FT-ONE THERMAL FAN CONTROL

100 W PA UNIT

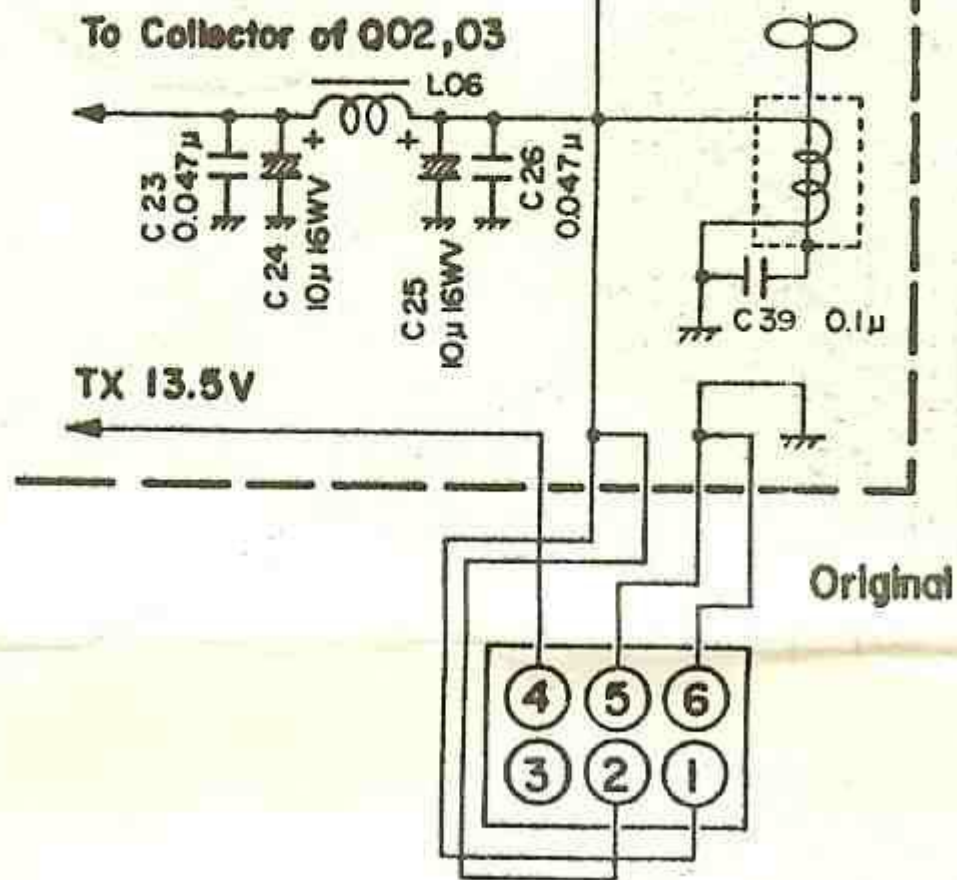
1. Remove the 100W PA Unit from the radio.
2. Remove the four screws from the 100W PA Unit, as shown in Figure 1.
3. Drill a 3mm (1/8 inch) diameter hole in the 100W PA Unit side cover, as shown in A of Figure 1 (Lot 1 and 2).
4. Apply thermal grease to thermal switch TS01, and install along with the diode (V06B) and the jumper wire, as shown in Figure 2 (3 x 8 screw, nut and spring washer provided).
5. Replace the four screws. Modification is now complete.
